UNITED STATES PATENT AND TRADEMARK OFFICE

APPLICATION NO.	FILING DATE	FIRST NAMED INVENTOR	ATTORNEY DOCKET NO.	CONFIRMATION NO.
09/782,257	02/14/2001	Syuuji Matsuura	0033-0692P	9932

Office Action Summary

Figure 1

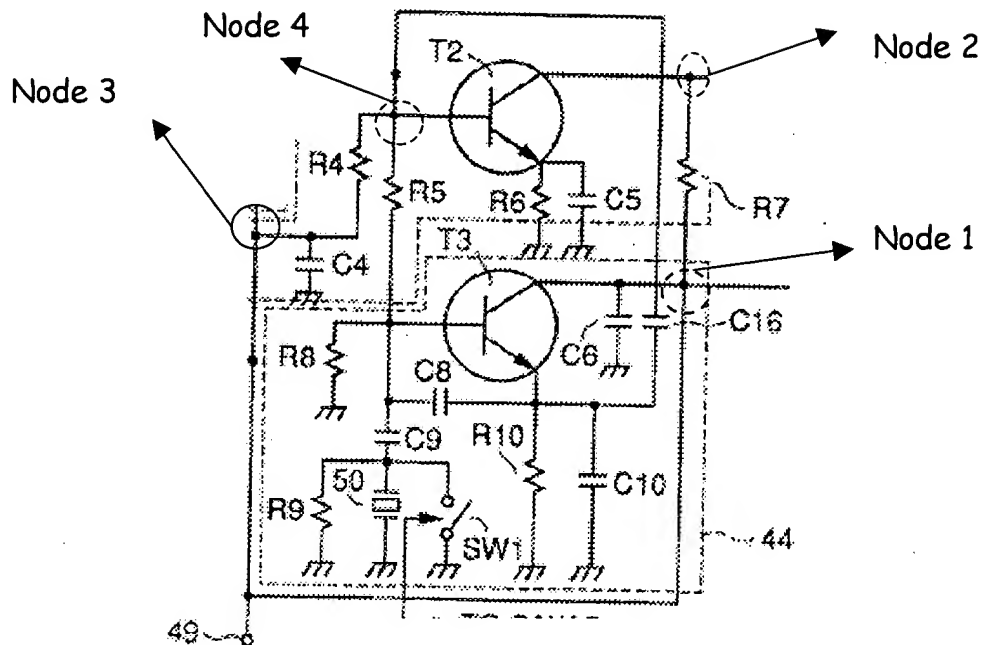
In regards to claim 6, it is unclear as to which node a "first voltage node" and a second voltage node applies (i.e. the "first node voltage" can correspond to node 4 or node 2, where a resistor is coupled the first and second transistors and a "second node voltage" can correspond to nodes 1 or 3, where the third biasing resistor can be element R4 or element R7, supplying a voltage higher than the first voltage node. See Figure 1 bellow for additional information). A bipolar transistor comprises three input/output terminals. Wherein the claim limitations recite "input electrode" and "output electrode", it is requested that specific input and output electrodes be labeled according to transistor junction labels (i.e., base, emitter, collector). Appropriate correction is requested in order clearly show the connections of the second bipolar transistor to the other elements.
